CITY OF ROCKVILLE HISTORIC DISTRICT COMMISSION STAFF REPORT

May 15, 2001 MEETING NO. 05-01

APPLICATION: HDC01-0188

ADDRESS: 215 Autumn Wind Way

Sun Porch on South Faade of Rose Hill Mansion, 215 Autumn Wind Way

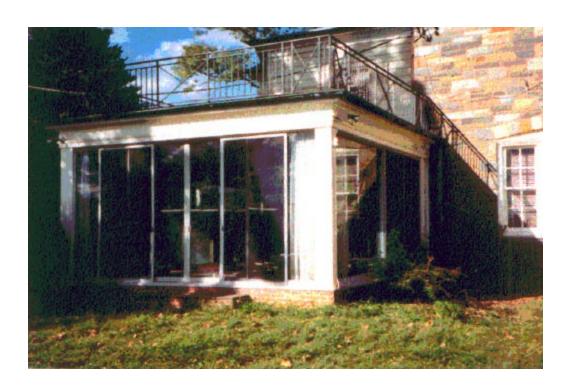
STAFF COMMENTS/RECOMMENDATIONS: Staff recommends approval of the window/door and fascia board replacements on the sun porch at 215 Autumn Wind Way. The sun porch appears to be a later addition to this historic resource. The materials to be replaced are modern materials and replacements will be of superior quality.

The exterior appearance of the renovated sun porch will be similar to the existing except that one full set of sliding doors on the east side of the porch will be replaced with a solid wall, a single fixed floor to ceiling window, and a pair of standard windows. This view of the porch is screened by boxwoods and is not highly visible from the right-of-way. The applicants are attempting to eliminate a view of an electrical box and utility meters from the interior of the porch by replacing the existing patio doors with shorter standard windows. Dry-vit stucco in a compatible color with the existing stone cladding will be applied to the solid wall exterior of the porch. The alternative cladding is clapboard, which is used only on the rear of the house, or brick to match the sunporch foundation. The Dry-vit appears to be the best choice for continuity and appearance in this location and will be compatible with the stone exterior of the main house.

STAFF RECOMMENDATION: Staff recommends approval of the replacement doors/windows and replacement of rotted fascia boards on the sun porch at 215 Autumn Wind Way. According to the Secretary of the Interior's Standards for Rehabilitation, Number 9, which states that:
